**RESPONSE TO
COMMENTS**

**MARINER'S POINTE
PROJECT**

**CITY OF NEWPORT
BEACH**

JUNE 2011

Upper Roof Plan

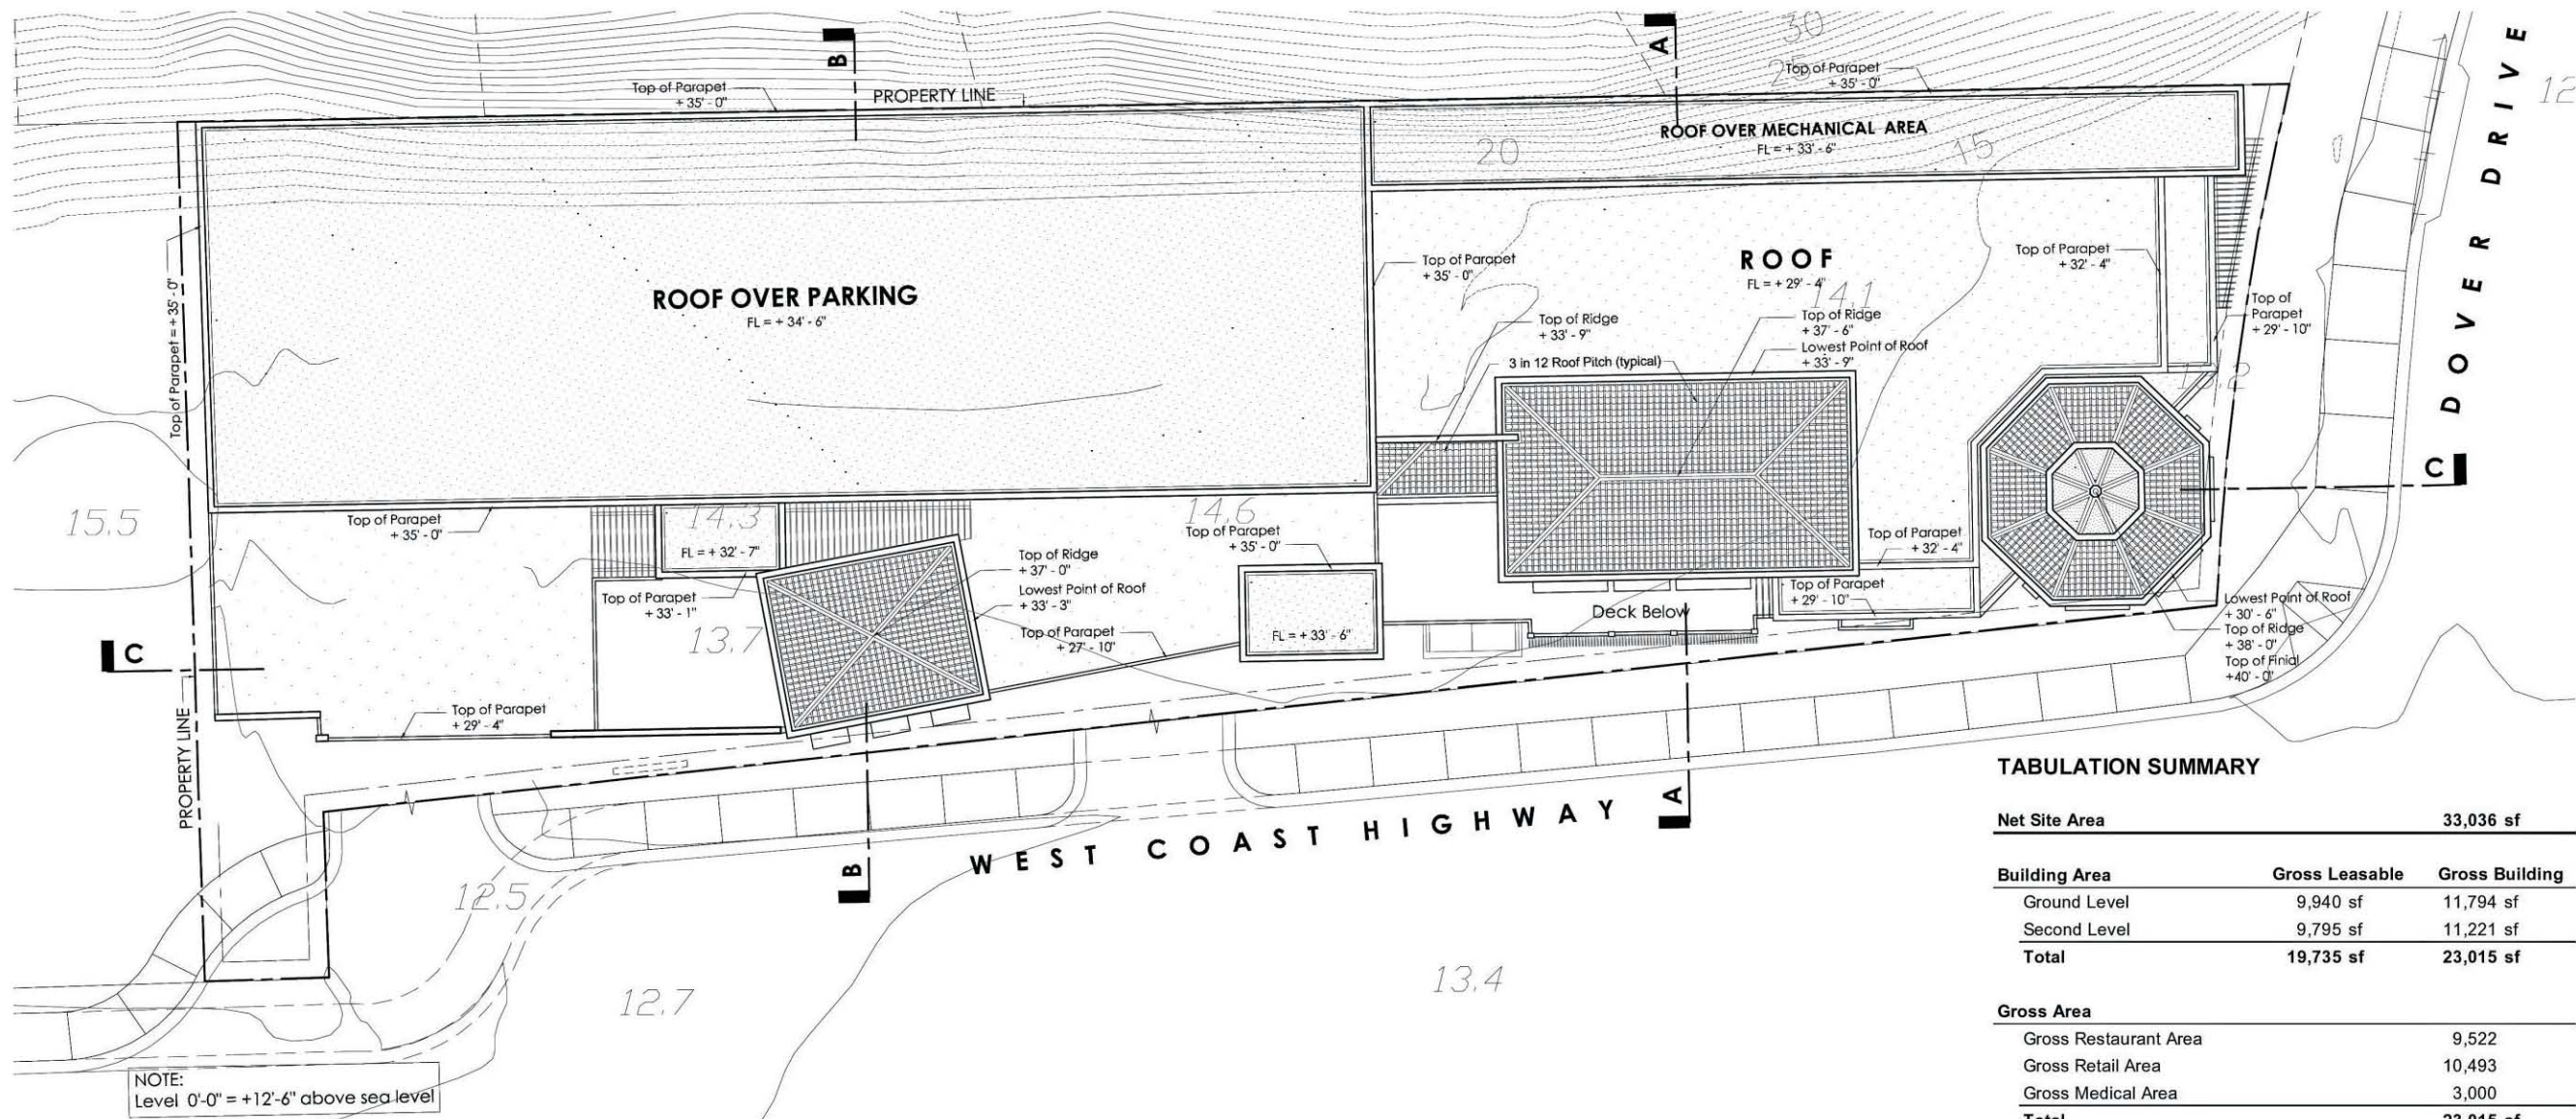
- A partial roof over the parking structure. The applicant is proposing this improvement to further minimize potential aesthetic and noise impacts per the concern of neighboring residents. These impacts, however, determined to be less than significant in the IS/MND would remain less than significant with or without this improvement.
- Height reduction in cupola and tower features. The original project includes these features at a maximum height of 44 feet. Based upon City staff review of the application, it was determined that the appropriate findings to approve a Modification Permit to exceed the allowed 40 foot height could not be made. Therefore, the applicant has agreed to reduce the height of these elements to a maximum 40 feet and withdrew their request for a Modification Permit.

Figure 1, *Upper Roof Plan*, shows the proposed partial enclosure of the rooftop parking level as submitted by the project applicant. The partial enclosure would cover approximately the rear two-thirds portion of the rooftop parking level and would be setback 37.5 feet from the face of the parking structure. As shown in Figure 2, the top of the rooftop enclosure would be approximately 35 feet in height.
